**Remedial Investigation Report
for Waste Area Grouping 27
at the
Paducah Gaseous Diffusion Plant
Paducah, Kentucky**

**REMEDIAL INVESTIGATION REPORT FOR WASTE AREA GROUPING 27 AT THE
PADUCAH GASEOUS DIFFUSION PLANT, PADUCAH, KENTUCKY
(DOE/OR/07-1777&D2)**

COMMENT RESPONSE SUMMARY
for Review Comments from
The United States Environmental Protection Agency
and the
Commonwealth of Kentucky Department of Environmental Protection

**Remedial Investigation Report for the Waste Area Grouping 27 at the Paducah Gaseous Diffusion Plant, Paducah, Kentucky
DOE/OR/07-1777&D2**

Fig. 4.4 Distribution of TCE in UCRS soil at SWMU 001.

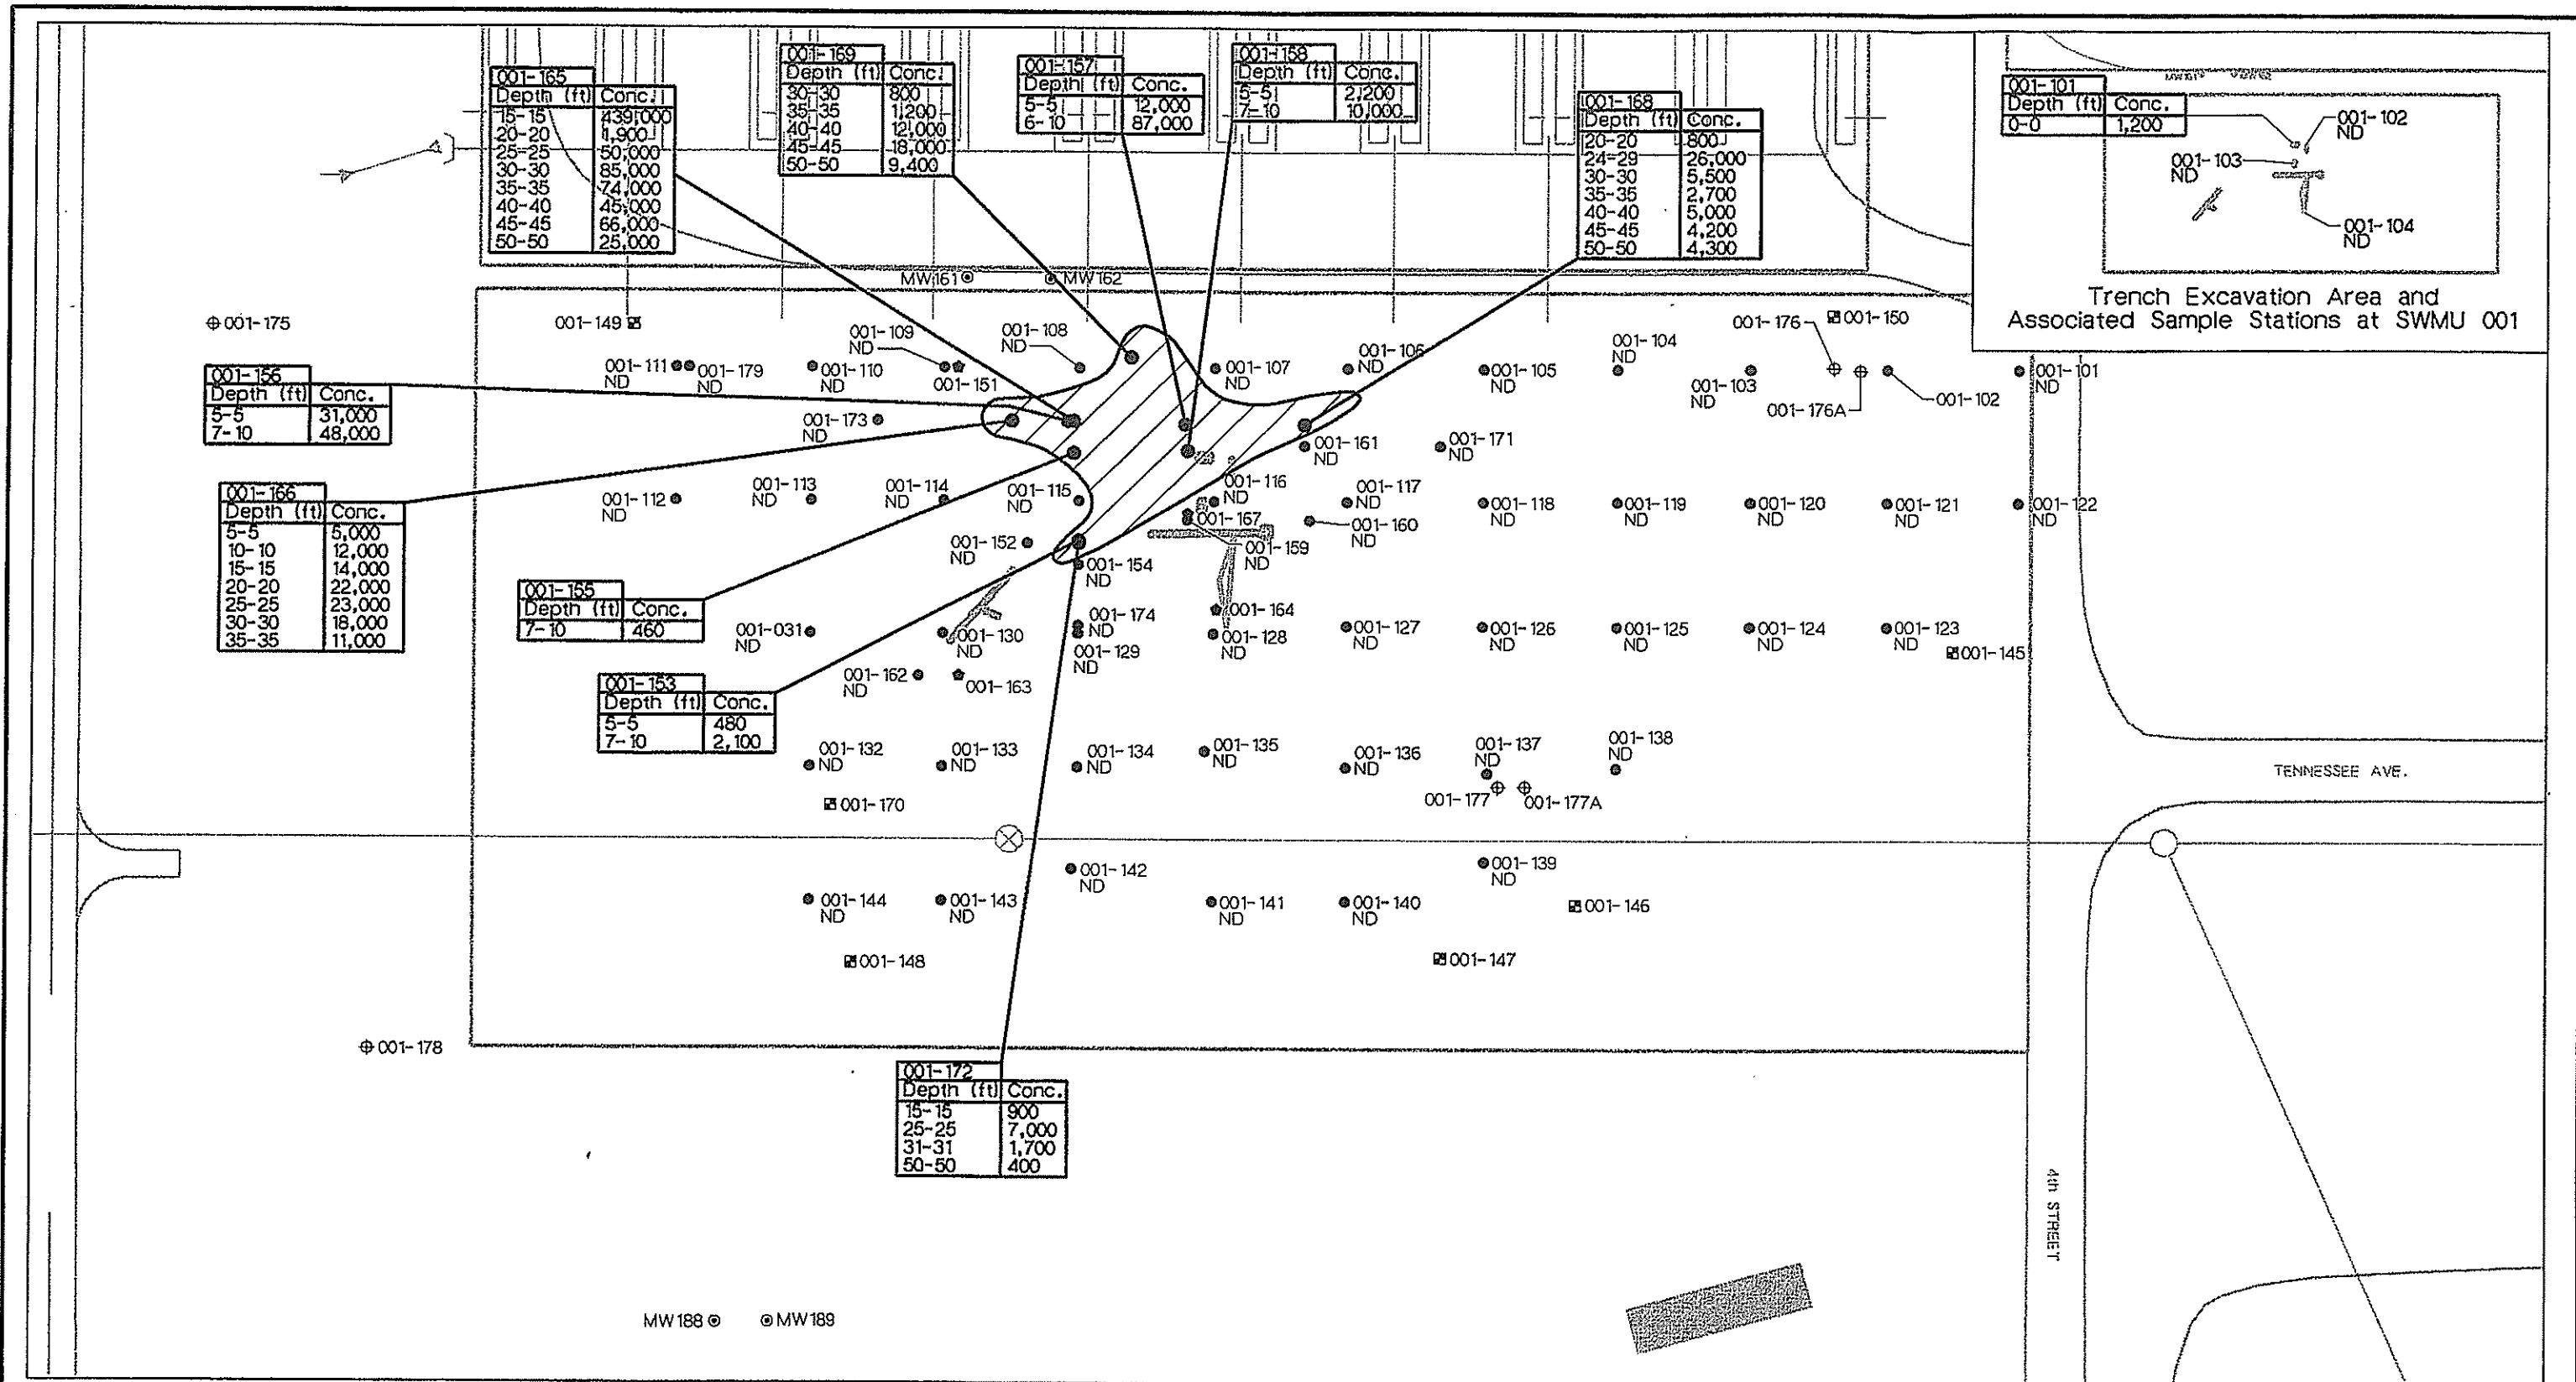
23	Volume 1; Figure 4.4	Distribution of TCE in UCRS Soil at SWMU 001: Sample locations 001-051 and 001-067 are not marked as being non-detect for TCE. However, results are not listed on the figure, in Table 4.4, or in Appendix H. Include these sample results at the appropriate locations within the RI report.	Four borings (001-051, 001-063, 001-064, and 001-067) were cone penetrometer test borings. Soil samples obtained from these borings were used to evaluate subsurface soil conditions at the site and were not submitted for laboratory analyses. These four locations have been labeled as CPT borings on SWMU 001 Figures 3.6, 4.3, 4.4, 4.7, and 4.8.

Comment No.	Section/Page/Para.	State Comment KDEP	Response
24	Volume 1; Figure 4.4	Distribution of TCE in UCRS Soil at SWMU 001: The crosshatched area depicting the zone of highest TCE soil contamination cannot be assumed to be completely accurate. For example, it is very likely that high levels of TCE soil contamination extend north of boring 001-069 beneath 25-feet. Although numerous borings were placed in this area many of these were shallow (i.e., 0-10 feet). Unless a decision is made to further characterize the soils from 0-50 feet in this area, any remedial action must involve cleanup of a larger region than that shown in this figure.	The distribution of TCE in soil boring 001-069 is concentrated between 40 and 50 ft bgs, which indicates that the TCE encountered at this location represents a smear zone near the top of the water table that has developed along the groundwater plume migration pathway. Therefore, the distribution of the identified contamination appears to be closely related to the groundwater and may best be addressed in the groundwater OU study. During development of the remedial design for the groundwater OU, decisions can be made regarding the need for additional characterization data at SWMU 001.

Fig. 4.23 North-south cross section A-A' showing TCE distribution in UCRS soils.

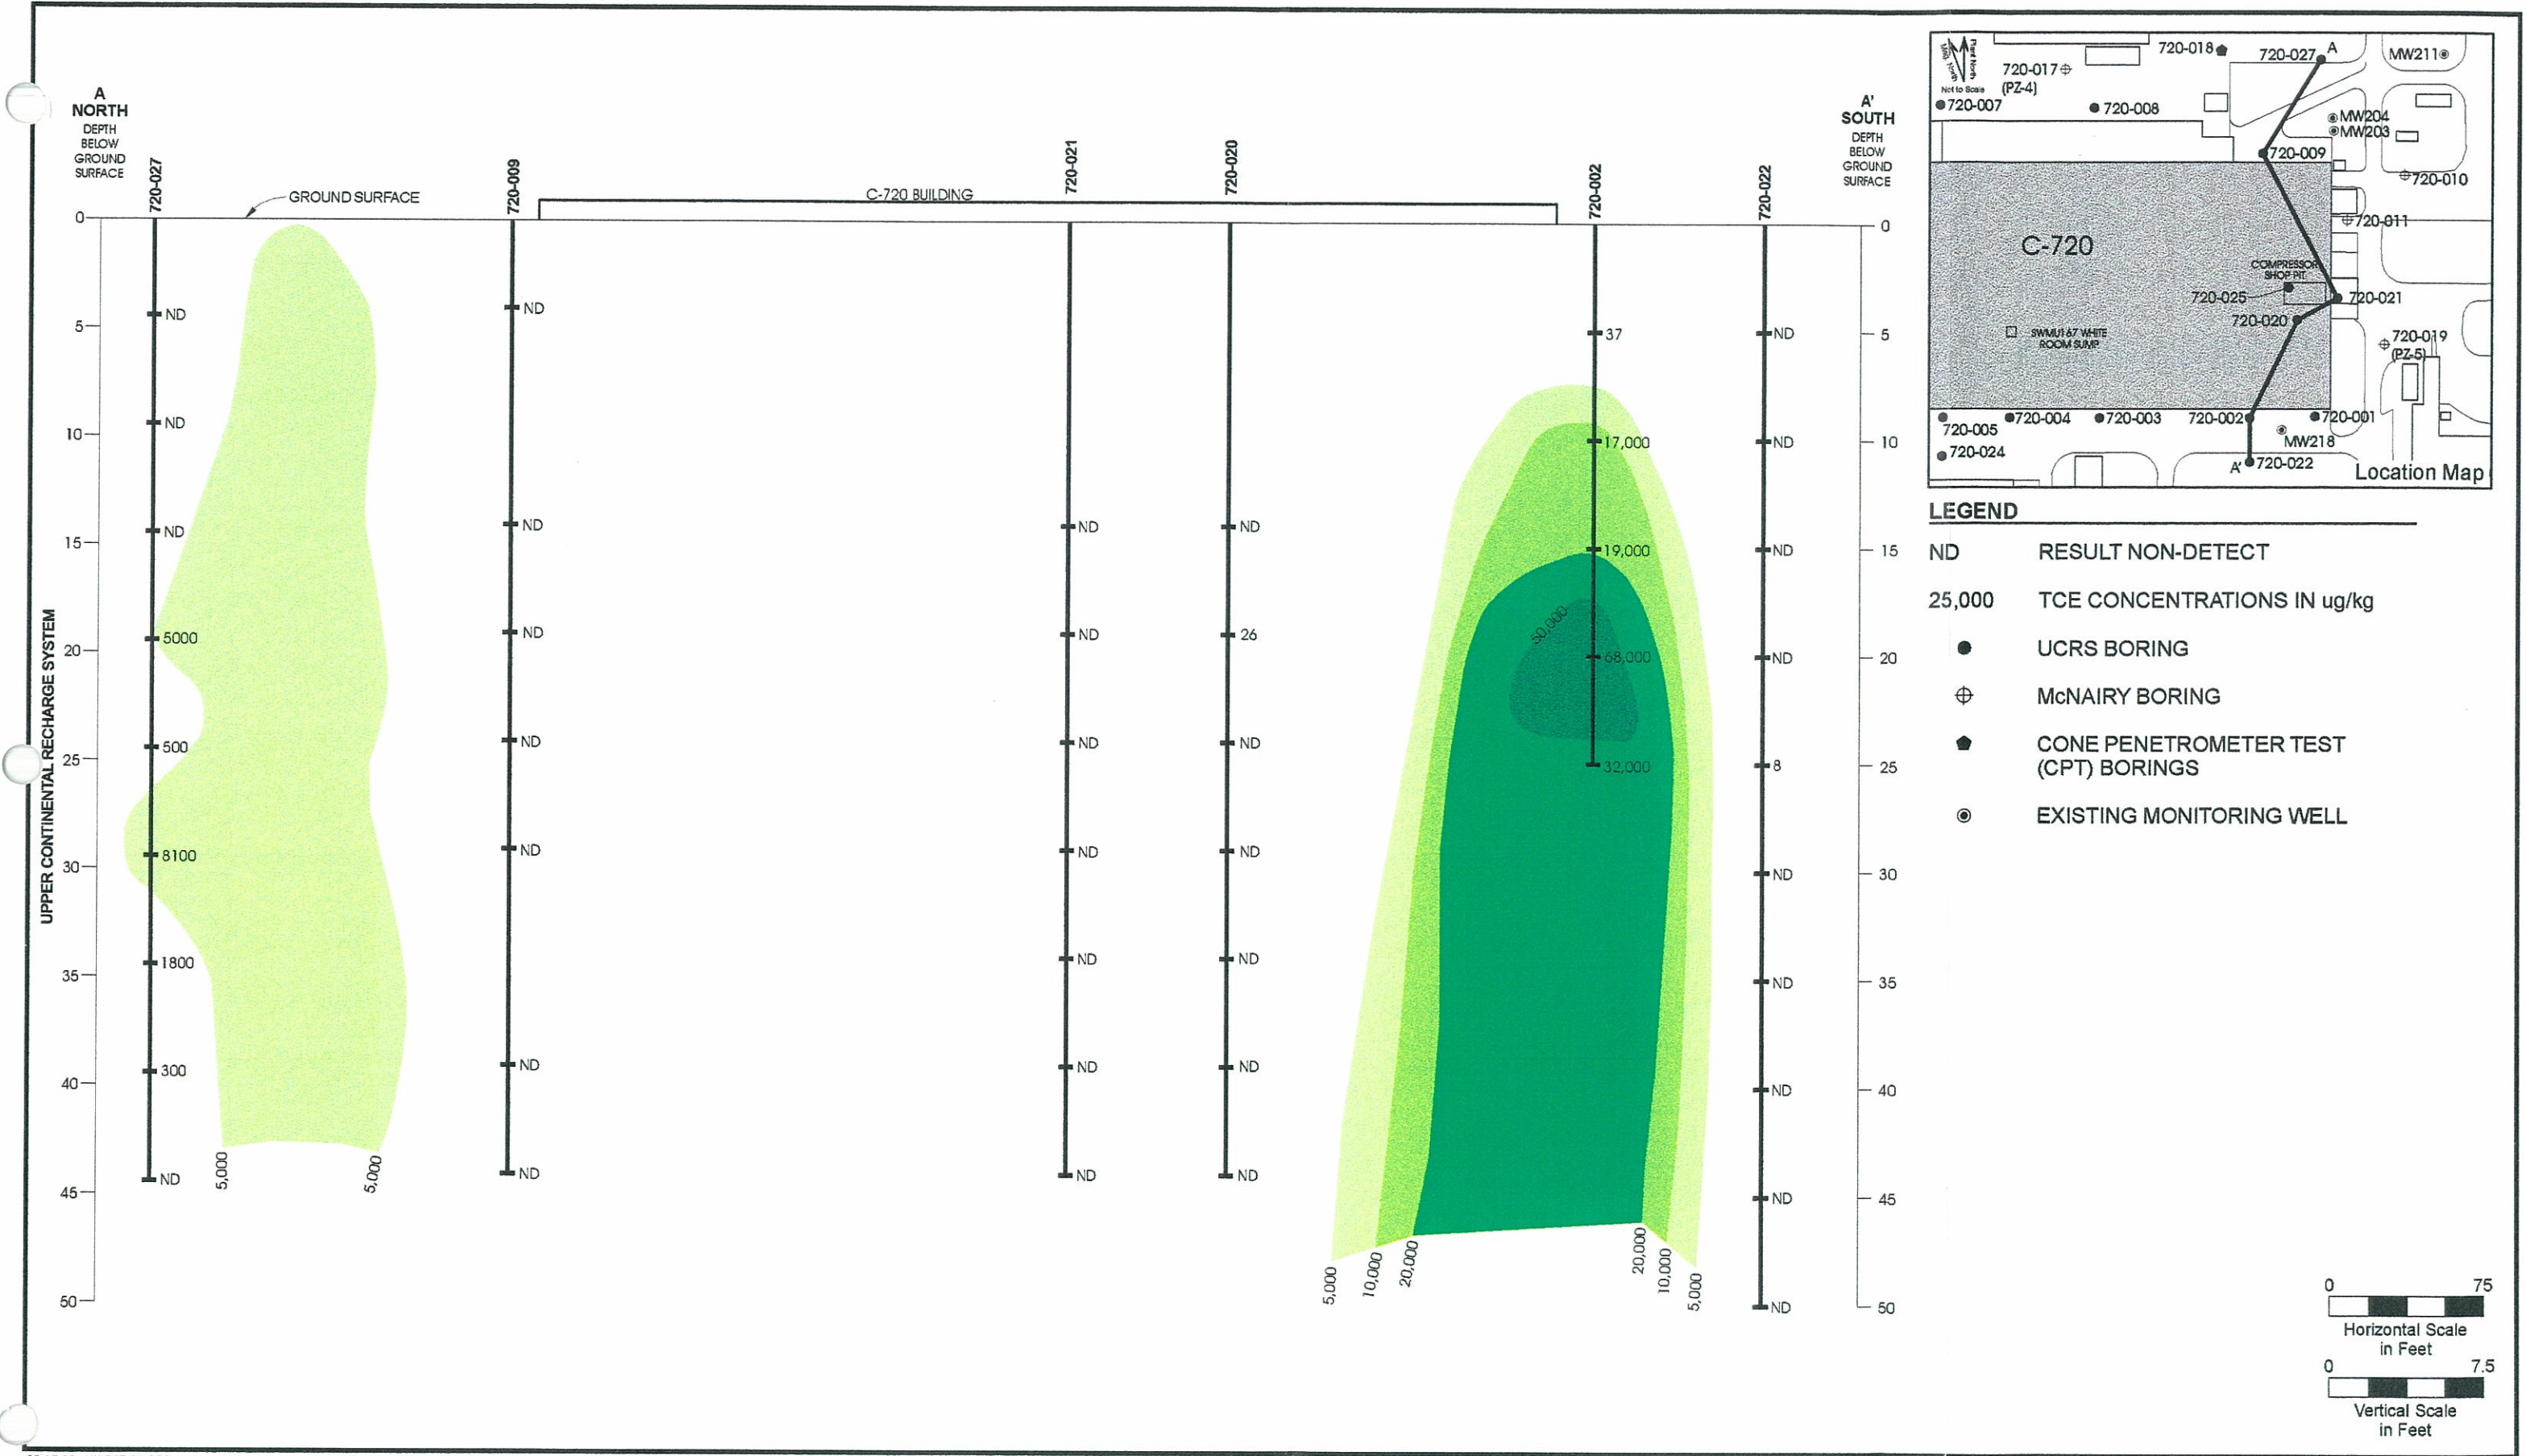
25	Volume 1; Figure 4.23	North-South Cross Section A-A Showing TCE Distribution in UCRS Soils: This profile shows an area of 10,000 µg/kg TCE soil contamination bounded by borings 720-027 and 720-009. There appears to be no sample data that would indicate the presence of 10,000 µg/kg TCE in this area. Explain how this data was contoured.	Agreed. The 10,000 µg/kg contour has been removed from the area between borings 720-009 and 720-027 on Figure 4.23.
26	Volume 1; Figure 4.29	Maximum Concentration of TCE in RGA Groundwater: According to the figure legend, all of the borings shown in this figure are UCRS borings. This is not the case and should be corrected. Revise this figure to indicate whether borings were completed in the RGA or the McNairy Formation.	Agreed. Boring location symbols shown in Figure 4.29 have been revised to correctly reflect the depth of the boring as defined in the legend.
